Re: Gila River Indian Community Comments on the Draft Class III
Underground Injection Control Area Permit for the Proposed Florence Copper
Project, Florence Copper Project Production Testing Facility, Florence, Pinal
County, Arizona

COMMENTS OF THE GILA RIVER INDIAN COMMUNITY ON THE DRAFT CLASS III UNDERGROUND INJECTION CONTROL AREA PERMIT FOR THE PROPOSED FLORENCE COPPER PROJECT PRODUCTION TESTING FACILITY

Subject: Florence Copper Project – Technical Aspects of the EPA Underground Injection Control Well Permit

Figure 3 - BHP Test Conditions - Uniform Hydraulic Conductivity - Particle Tracks

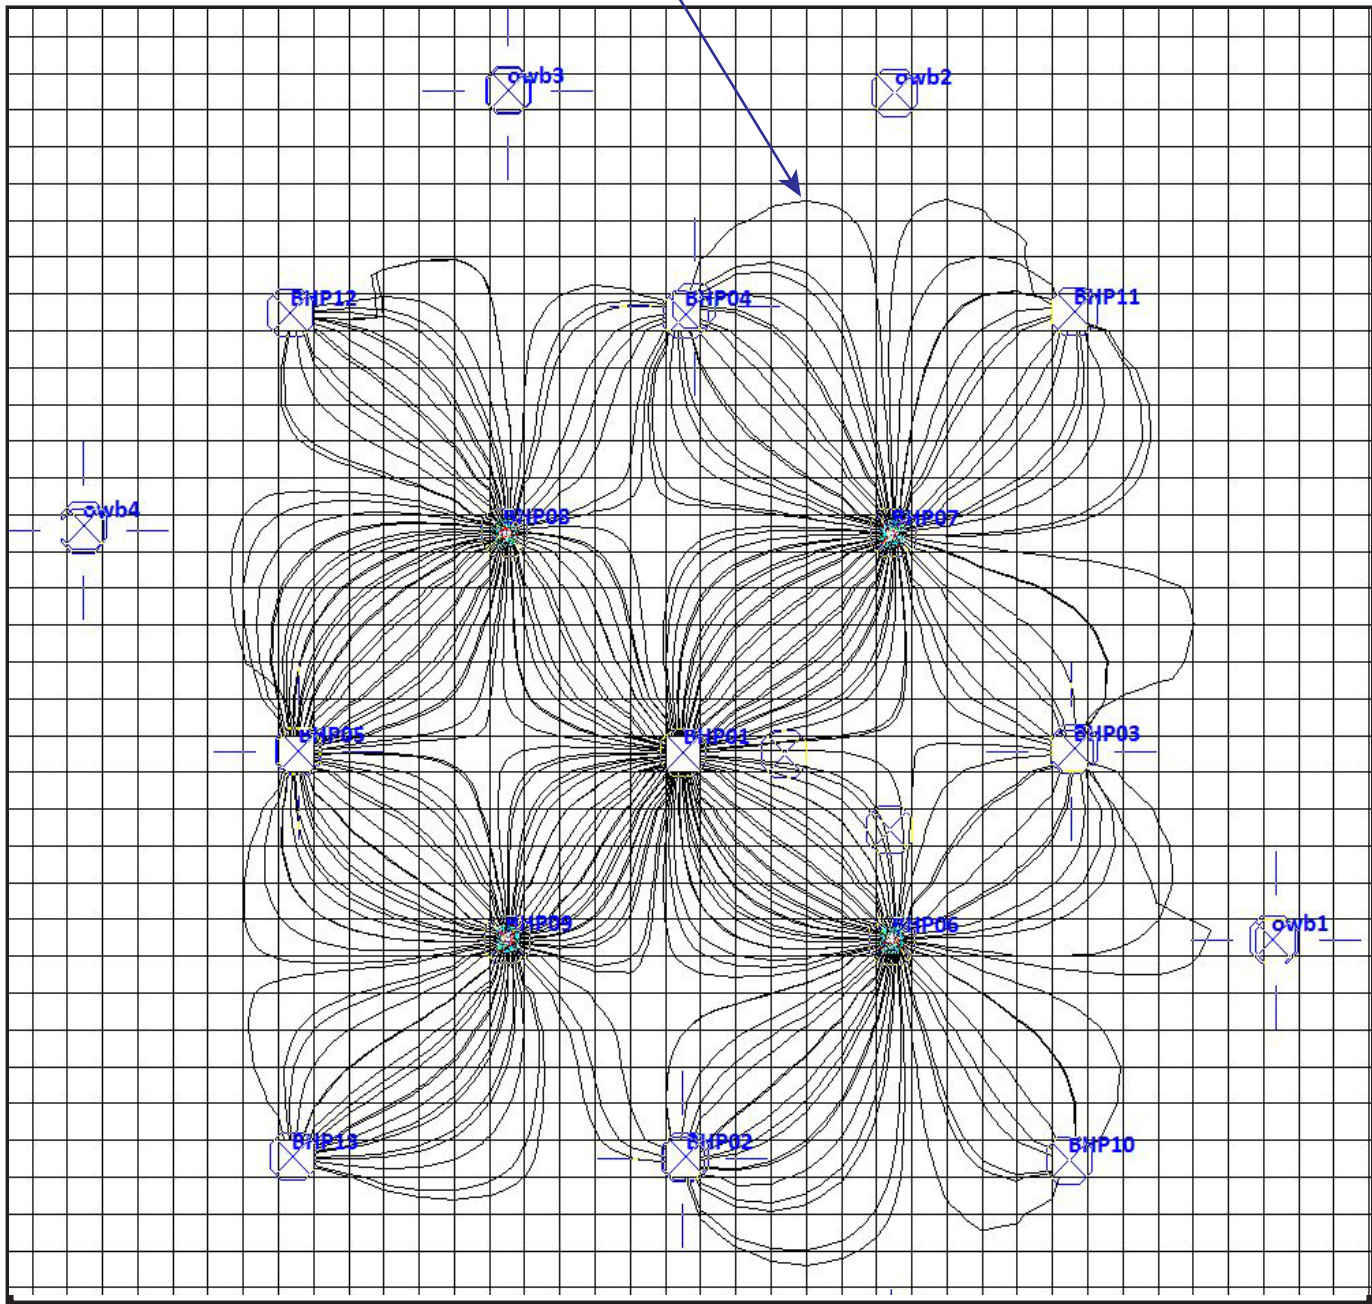
When a uniform value of K was used, the simulated tracks of particles indicate that particles starting at the injection wells can escape from between the enclosing extraction wells for the arrangement of pumping rates used during the BHP operations. However, the pumping pulls such particles back into the extraction wells. See Figure 3 for the simulated particle tracks resulting from the case of using a uniform K to simulate the BHP operations.

Particle Track escapes
between extraction wells
but is pulled back

Figure 4 - BHP Test Conditions - Variable/Calibrated Hydraulic Conductivity Particle Tracks

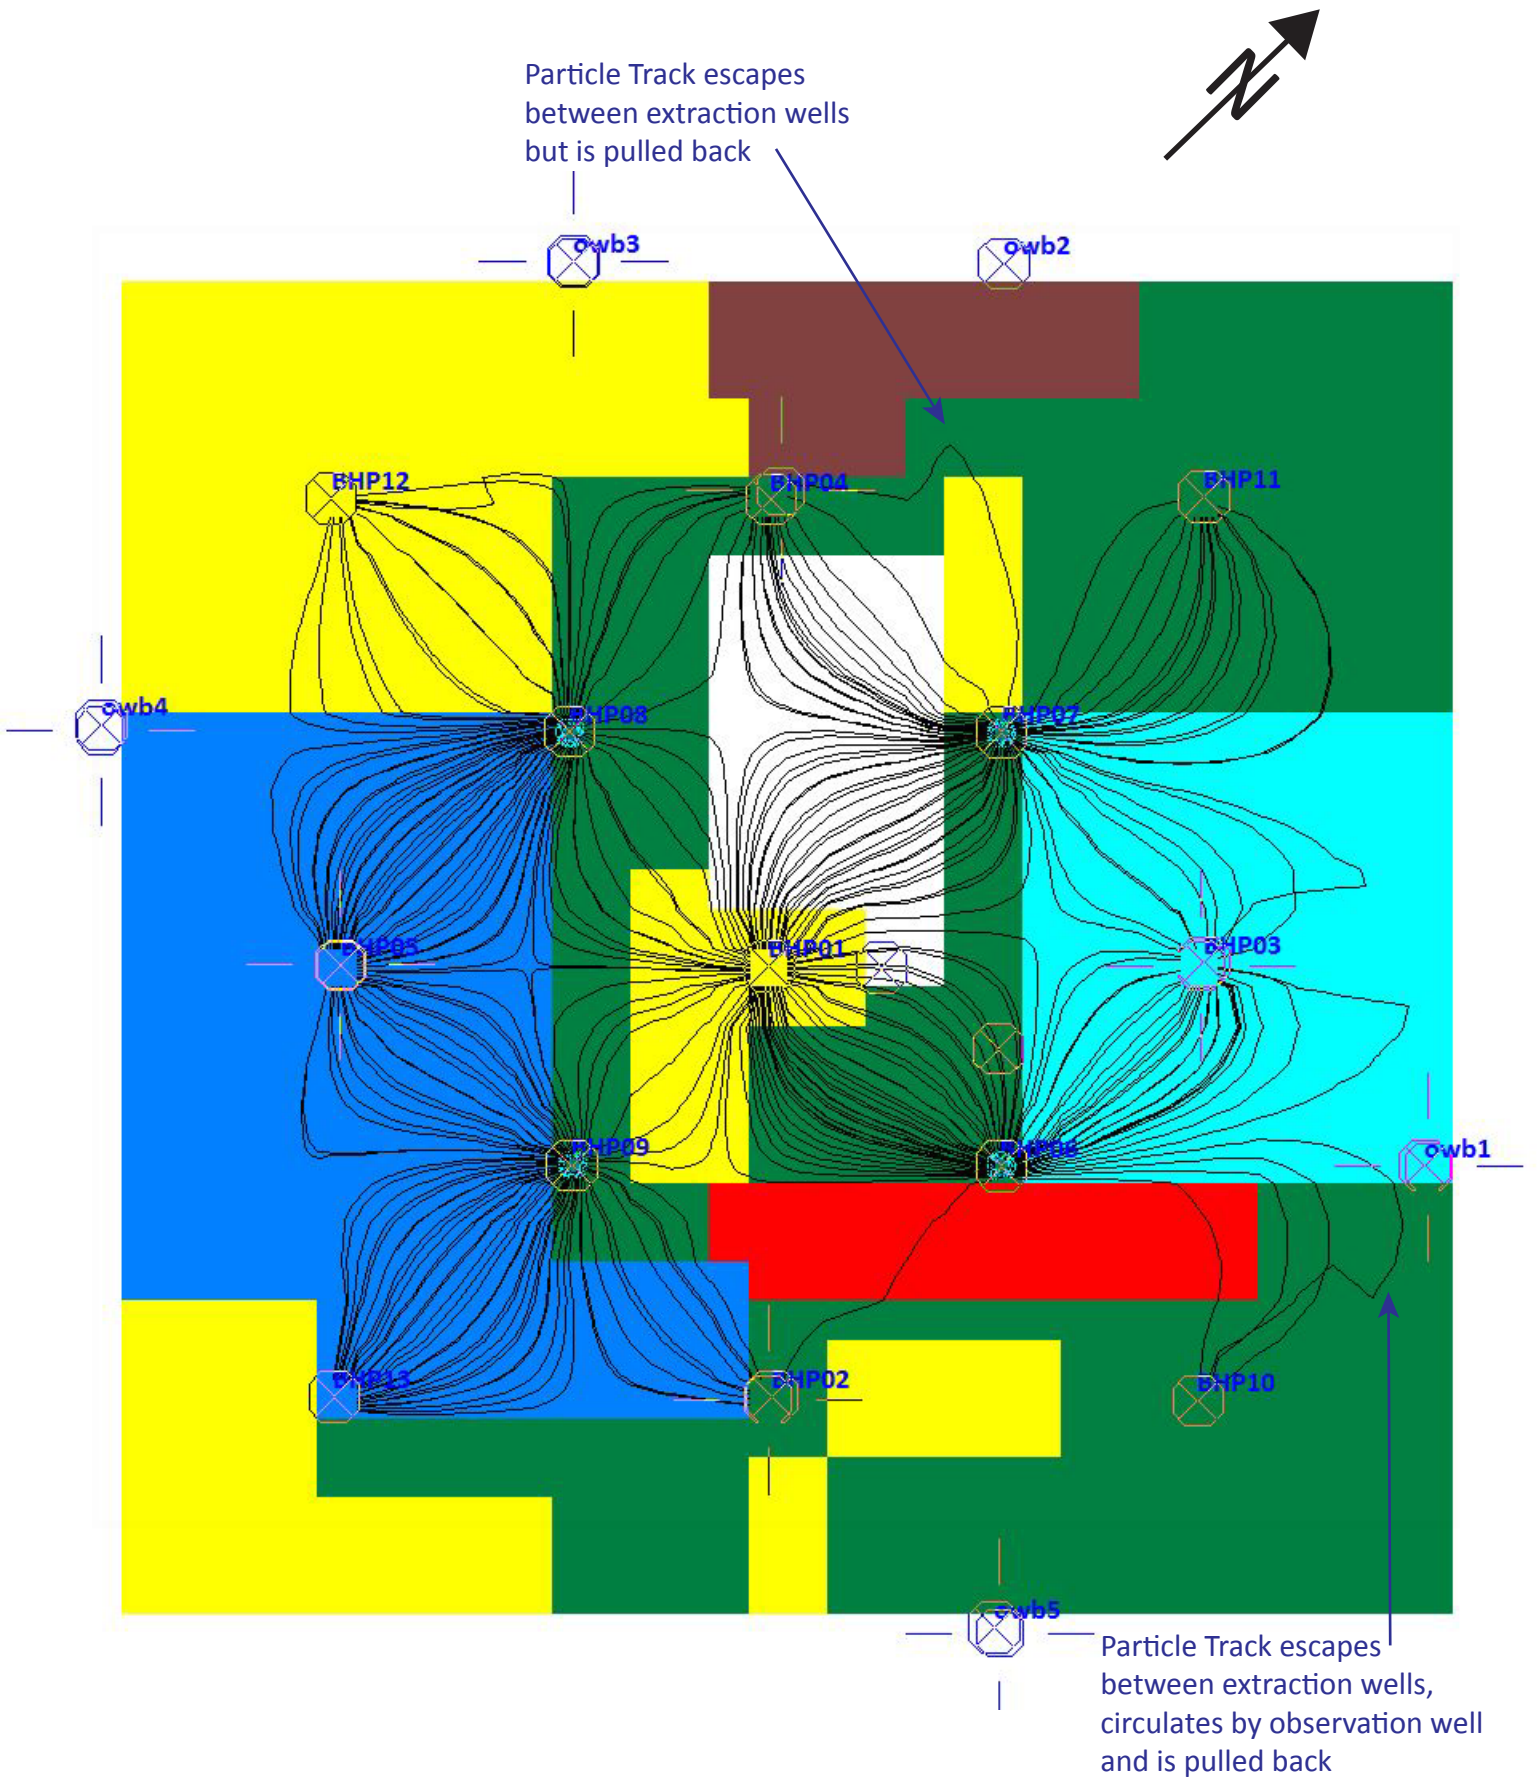
When the calibrated K distribution presented by BHP was used, similar results were found; though there was concentrating and spreading of the particle paths caused by heterogeneity between the injection and extraction wells. See Figure 4 for the simulated particle tracks resulting from the case of using the variable, zoned K distribution from BHP to simulate the BHP operations.

Figure 5 - BHP Test Conditions - Streak in Hydraulic Conductivity - Particle Tracks

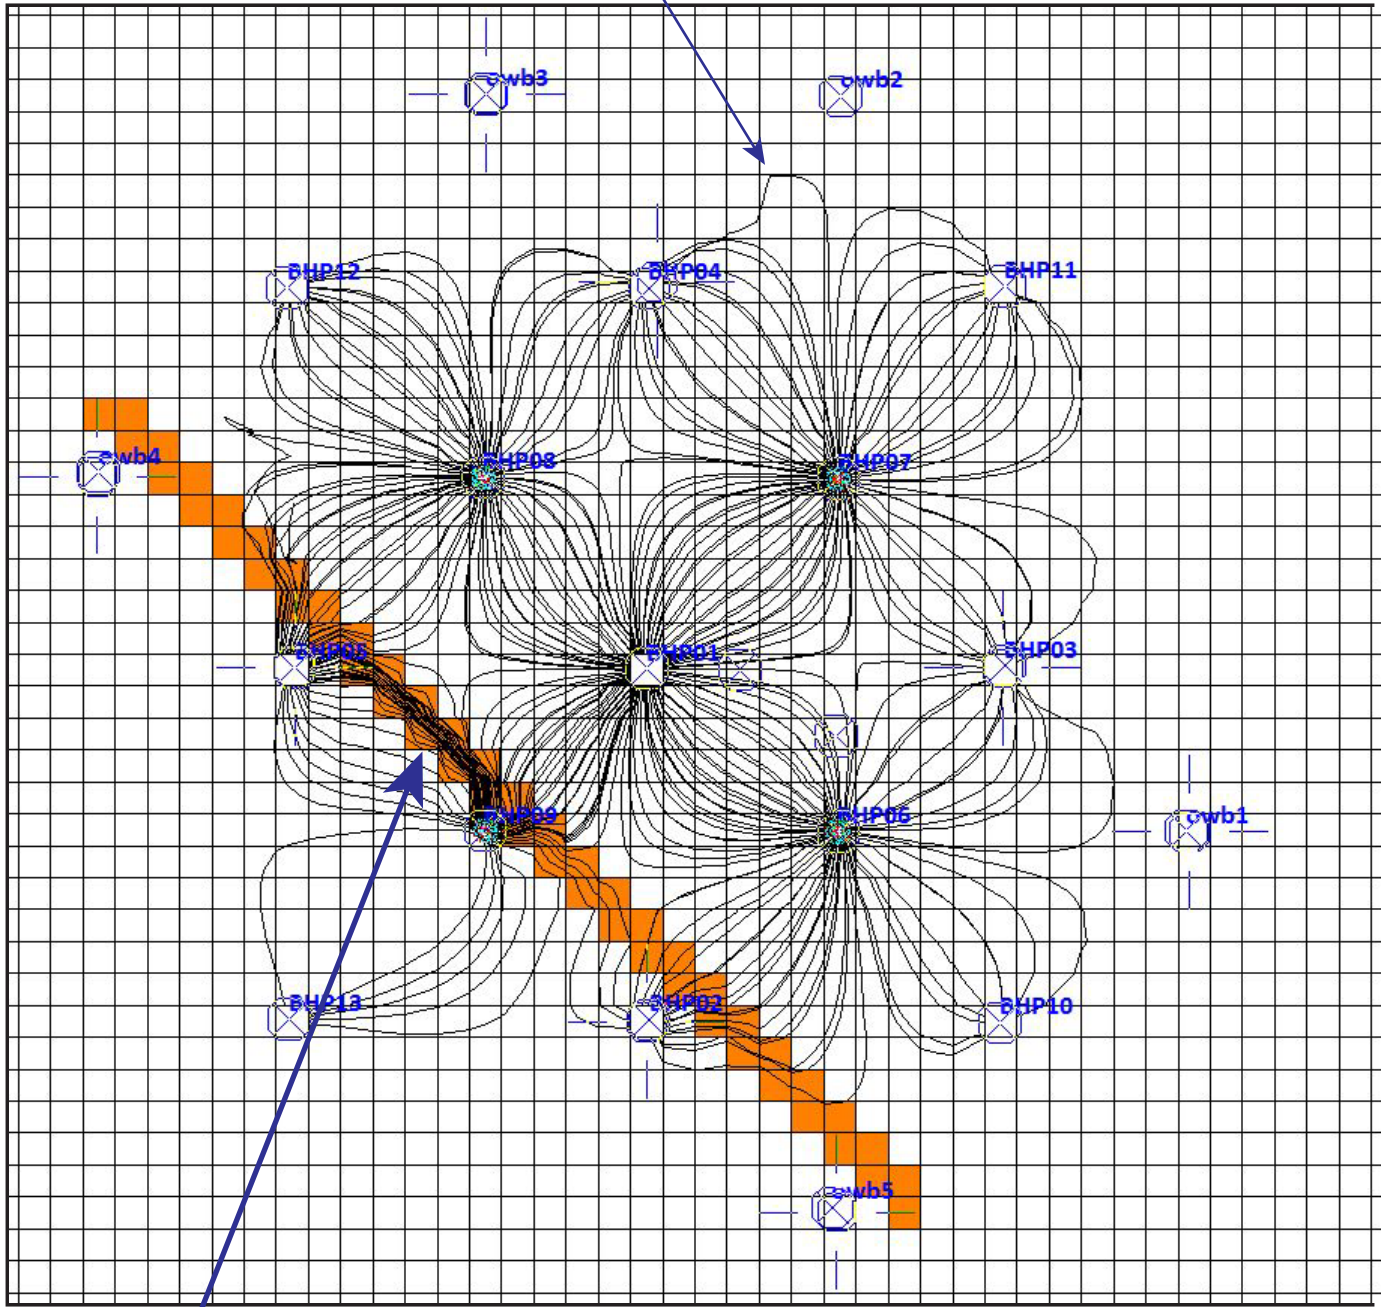
When the streak of high K also presented by BHP was used, the short circuiting between wells BHP 5 and BHP 9 simply concentrated nearby particle paths into the streak. This is a more pronounced version of the effect of heterogeneity also seen in parts of the calibrated K distribution results. The results were similar regarding the escape and recapture as noted for the other two cases. See Figure 5 for the simulated particle tracks resulting from the case of using the streak of high K from BHP to simulate the BHP operations.

Particle Track escapes
between extraction wells
but is pulled back

Streak of $K = 9.7 \text{ ft/d}$
Note channeling between wells

Figure 6 - One Year On, One Year Off - Uniform Hydraulic Conductivity - Particle Tracks

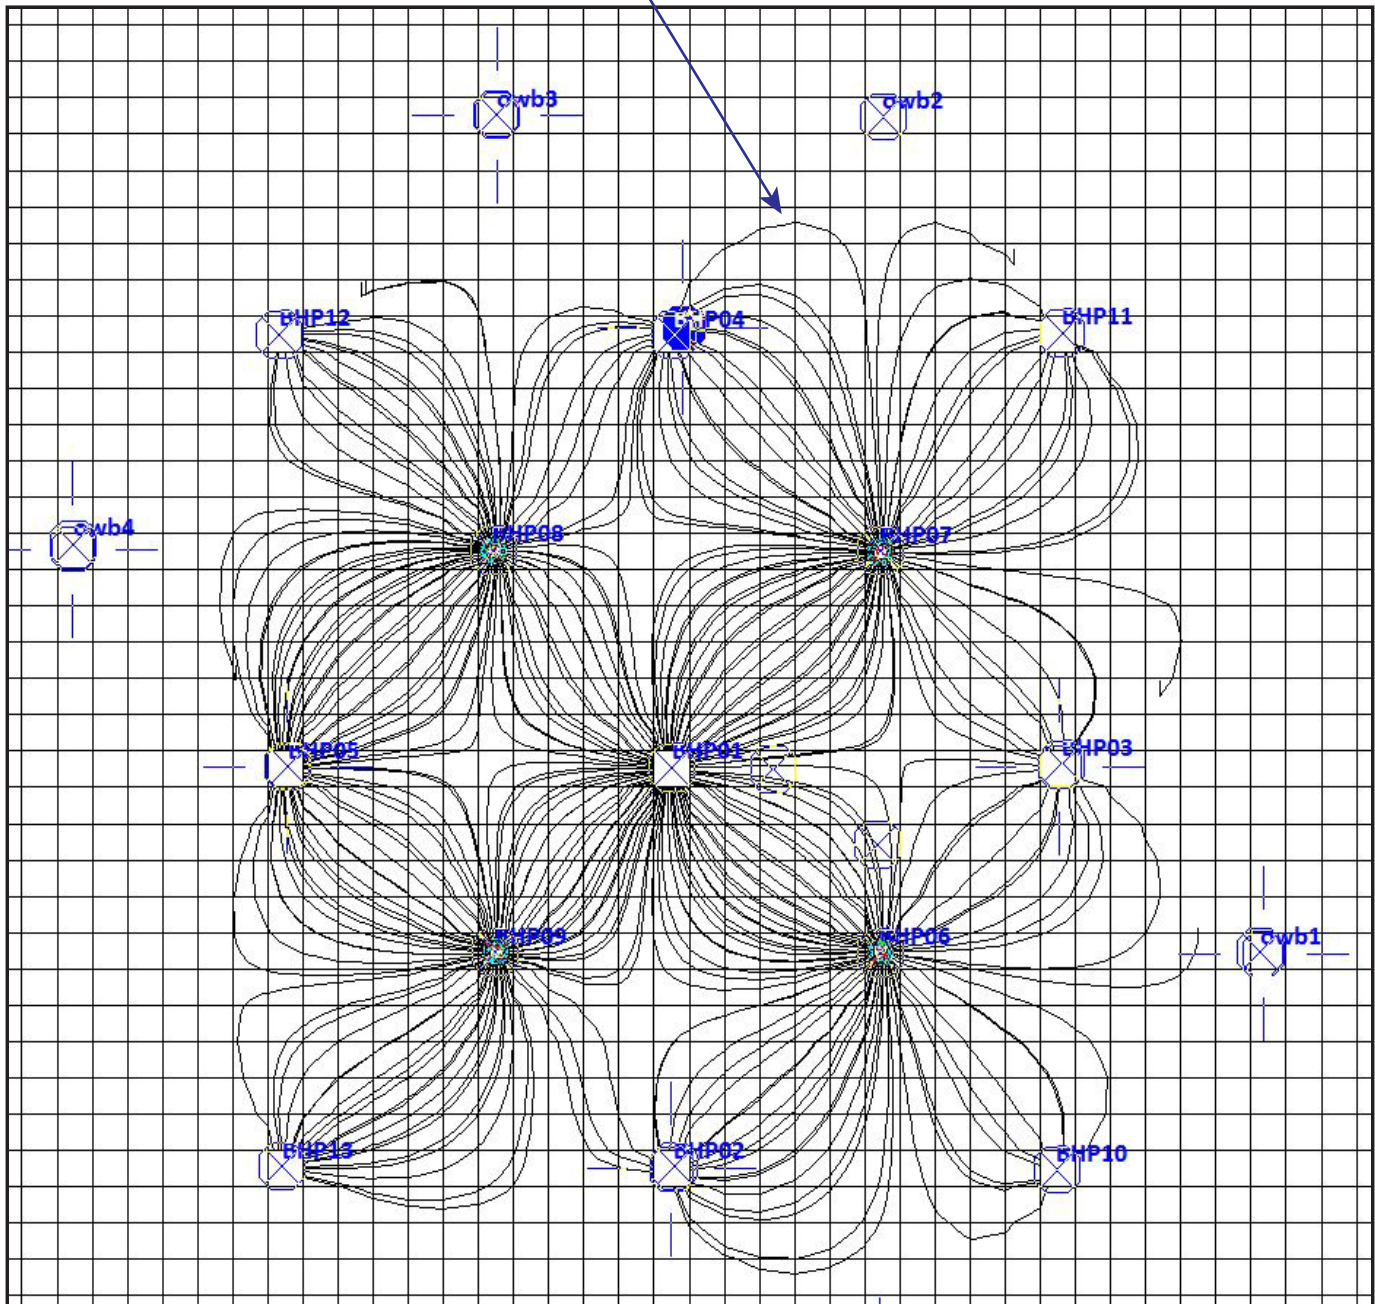
Two additional simulations were prepared to observe the effects of individual pumping rates. The rates during the official 90-day Pilot Test were extended for a year and then turned off. As extraction is continued, the particles were drawn around and back into the extraction wells. It appears that the observed spikes of low pH and elevated sulfate at some observation wells noted in the data by the Appellants could be explained by travel along the particle tracks similar to those simulated here for the test. There was more than a one foot inward water level difference between the locations of the extraction wells and the observation wells just outside when this escape was occurring. See Figure 6 for the simulated particle tracks resulting from the case of using a uniform K and extending the 90-Day BHP test rates for a year and then turning them off. The water particles not yet drawn into an extraction well when the system is turned off will eventually head away from the test wells with the background groundwater flow.

Particle Track escapes
between extraction wells
but is pulled back

**Figure 7 - One Year On, One Year Off - Uniform Hydraulic Conductivity - Particle Tracks
Move Half of Extraction on Downgradient Side to Upgradient Side**

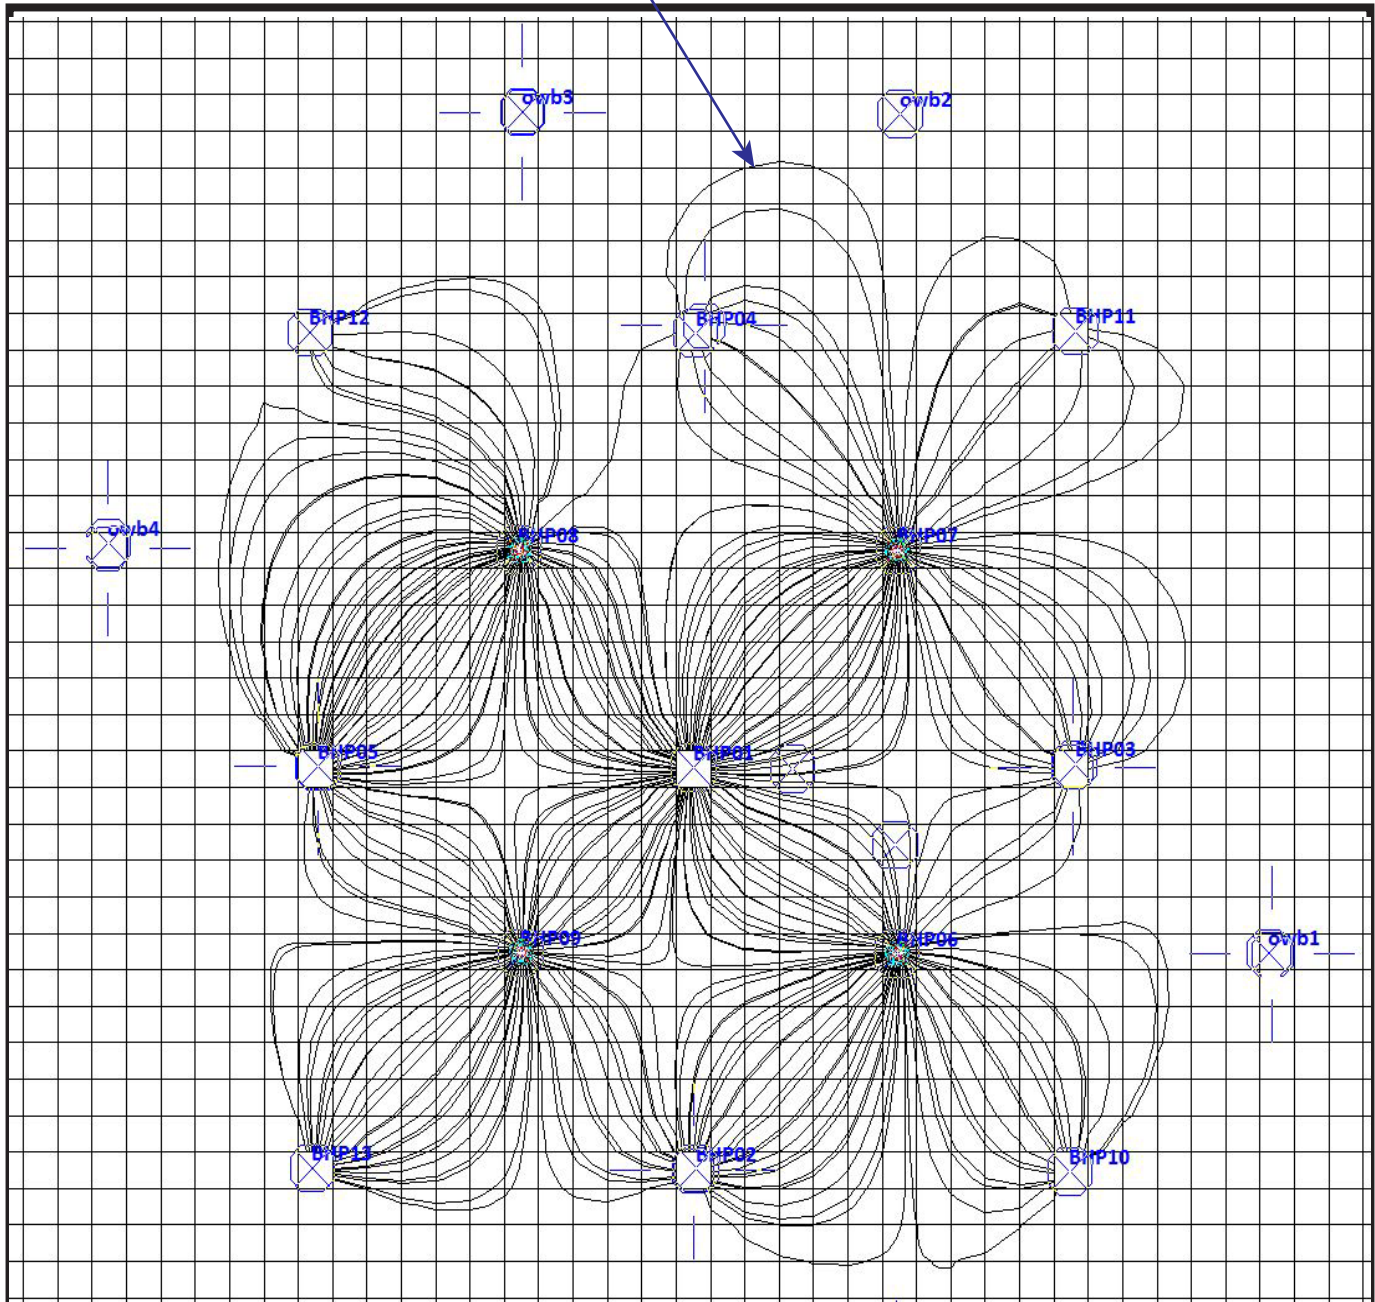
When the pumping rates for the three downgradient wells were decreased by half and these rates were added to the three upgradient extraction wells, the potential for drawing water back into extraction wells was more evident in that particles proceeded farther down gradient between the extraction wells, but were eventually drawn back in. Again, there was more than a one foot water level difference between the locations of the extraction wells and the adjacent observation wells. See Figure 7 for the simulated particle tracks resulting from the case similar to that of Figure 6, but with half of the pumping at the downgradient extraction wells transferred to the upgradient extraction wells.

Particle Track escapes farther
between extraction wells
but is pulled back
